# Access Compliance Report

## Public Rights-of-Way

Intersection ID: 49504	Main Street: OLD_POTTERS_RD	Cross Street: WATERLOO_DR	Location: SW
ADA ID: B9E2A0800776	Ramp Type: PerpDiag	Initial Pass/Fail: Fail	Overall Compliance: No
		Severity Score: 25

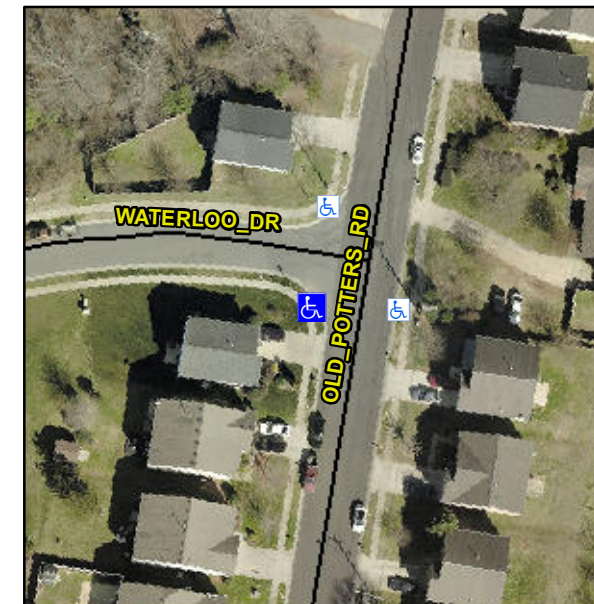
**Not Found, R304.2.2**

Compliance	Description	Data	Compliance	Description	Data
N/A	Ramp Length (in)	49.0	No	Ramp Slope (%)	15.9
Yes	Ramp Width (in)	48.0	Yes	Ramp XSlope (%)	0.1
N/A	Flare Type LT	N/A	N/A	Flare Type RT	N/A
N/A	Flare Slope LT (%)	N/A	N/A	Flare Slope RT (%)	N/A
N/A	Flare Traversable LT?	N/A	N/A	Flare Traversable RT?	N/A
N/A	Landing Length (in)	N/A	N/A	DWS Provided?	N/A
N/A	Landing Width (in)	N/A	N/A	DWS Contrast?	N/A
N/A	Landing Slope (%)	N/A	N/A	DWS Length (in)	N/A
N/A	Landing X Slope (%)	N/A	N/A	DWS Full Width?	N/A
N/A	Landing Curb? (Y/N)	N/A	N/A	DWS Offset (in)	N/A
N/A	Shared Landing?	N/A			
N/A	Gutter Ponding?	N/A	N/A	Gutter Slope (%)	N/A
N/A	Gutter Lip Ht (in)	N/A	N/A	Gutter X Slope (%)	N/A
N/A	Painted X Walk1?	No	N/A	Painted X Walk2?	No
	X Walk 1 Direction	To E		X Walk 2 Direction	To N
N/A	X Walk 1 Width (in)	N/A	N/A	X Walk 2 Width (in)	N/A
	X Walk 1 Slope (%)	0.6		X Walk 2 Slope (%)	0.9
	X Walk 1 X Slope (%)	2.4		X Walk 2 X Slope (%)	0.8

**Remove & Replace Curb Ramp With Two New Directional Ramps or Equivalent.**
